# Access Compliance Report

## Public Rights-of-Way

### (Pedestrian Signals)

Intersection ID: N/A	Main Street:	Cross Street: N/A	Location: N/A
ADA ID: 88CB4845BF0D	Signal Type: One Push Button-Non APS	Overall Compliance: No	Severity Score: BTN 1: N/A BTN 2: N/A No BTN: N/A
Codes/Mitigation Info/Possible Solution		Field Measurements/Component Compliance

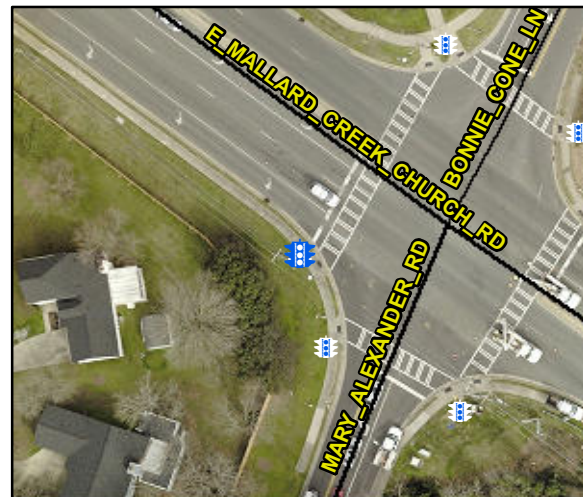
N/A	B 1 Clear Xing Direction?	Yes	N/A	B 2 Clear Xing Direction?	N/A
	B 1 Crossing Direction	To N		B 2 Crossing Direction	N/A
No	B 1 DistanceTo XWalk (in)	61.0	N/A	B 2 DistanceTo XWalk (in)	N/A
No	B 1 DistanceTo Curb (in)	107.0	N/A	B 2 DistanceTo Curb (in)	N/A
Yes	B 1 Diameter (in)	2.0	N/A	B 2 Diameter (in)	N/A

Possible Solutions: Replace Signal Push Button With APS Button on New Post. Remove & Relocate Sign.
